XC90 Courtesy Upgrade (C-10006)

REF NO: TJ 30991	ISSUING DEPARTMENT: Technical Service	CAR MARKET: United States and Canada	
PARTNER: 3 US 7510 Volvo Cars North America		ISSUE DATE: 2016-03-10	STATUS DATE: 2016-04-19
FUNC GROUP: 3600	FUNC DESC: Other electrical equipment	Page 1 of 10

XC90 Courtesy Upgrade C10006: Technician Instructions

Digital Owner's Manual before & after Courtesy Upgrade

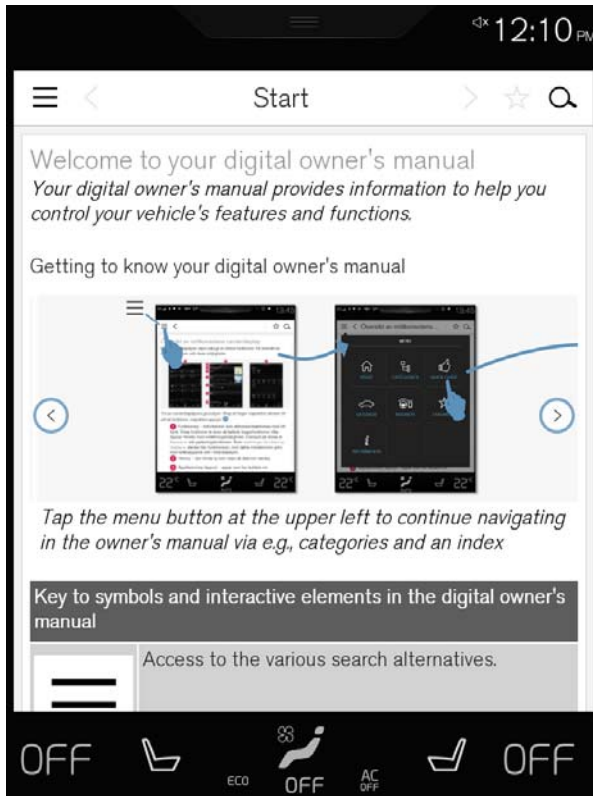
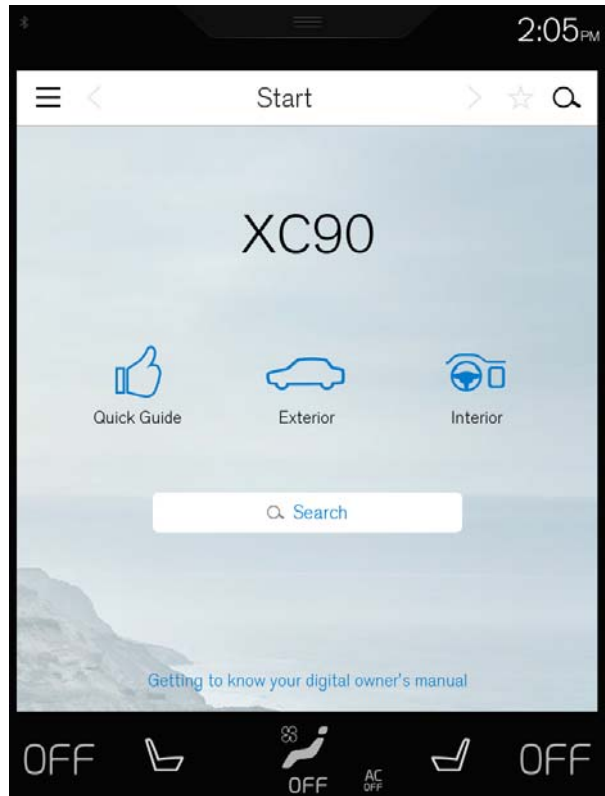
One easy way to check if this update has been performed is by accessing the Digital Owner's manual.
